North Shore Health Hub Modification – Tower A (Mod 4), Tower B Concept (Mod 2) and Tower B Stage 2 (Mod 2)

Minor change to plantroom roof form and material
State Significant Development Modification Assessment
(SSD-7543-Mod-4, SSD-8499-Mod-2 and SSD-8894-Mod-2)

July 2020

Published by the NSW Department of Planning, Industry and Environment

Figure 3 | Tower A Eastern Elevation (Source: Billard Leece)

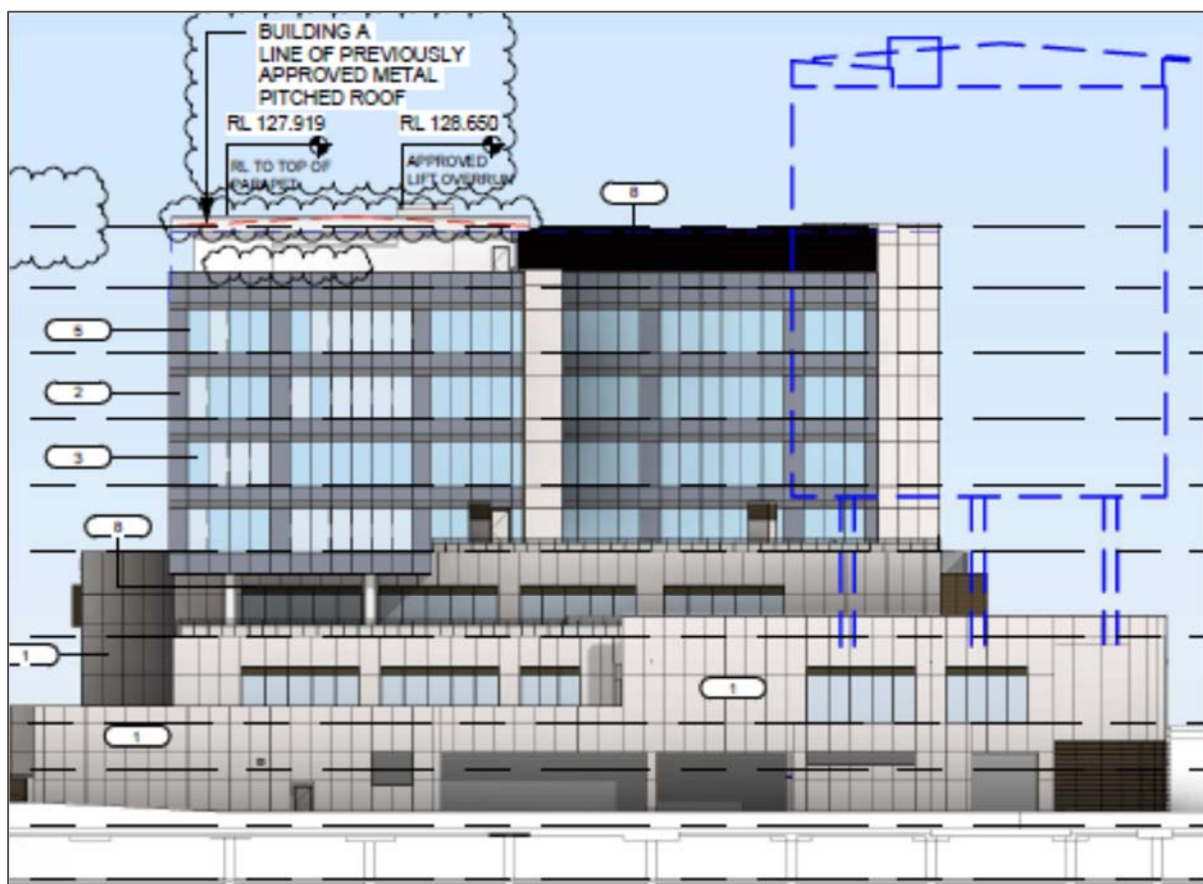
Low pitched metal roofs on both the Tower A and Tower B buildings are proposed to be replaced with flat concrete roofs. The Applicant has stated that the proposed modifications have arisen from further detailed design refinement and review of construction programming and are aimed providing a more functional design and more efficient construction methodology, particularly given the challenges faced on construction sites regarding COVID-19. In this regard, the modification will have the following positive impacts from a buildability perspective:

The proposed modifications will not result in any further environmental impacts in terms of overshadowing or visual amenity. The proposed concrete plant room roof construction is only perceivable from taller adjacent buildings (i.e. the upper floors of the Kolling Institute building), while from street level the concrete roof slab will not be seen. Only the underside and leading edge of the new eaves are visible, and they will be largely indistinguishable from the previously approved metal roof eaves.

The Department is satisfied that the proposed modifications to Tower A and B are minor and largely a response to COVID-19 safety practices. The overall approved maximum building heights will not change and no changes to floor area or land uses are proposed.
